Wellington Street Bicycle Infrastructure,
between Johnston Street and Queens
Parade

Road Safety Audit

Audit Stage: Existing Conditions

| Report number | S20230305-REP-001 |

SB sightlines at Sackville Street

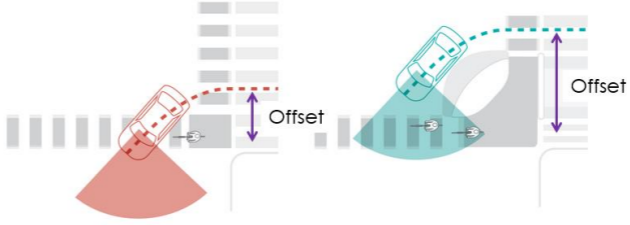
9) Auditors note that vehicles turning onto Wellington Street from its side roads typically have obscured sightlines of oncoming traffic due to parked cars and vegetation. Auditors are concerned that motorists will hold their vehicle in the bicycle lane and may proceed through the intersection to have a clear view of any oncoming traffic, increasing the likelihood of bicycle-vehicle and vehicle-vehicle crash types. This issue is present at many side road intersections with Wellington Street.

Consider pruning overgrown vegetation and banning parking close to the side road intersections (with NO PARKING signage), per AS1742.11, to open sightlines. (S)

Consider conducting sight line checks at all side streets to identify and prioritise high-risk sites. (S)
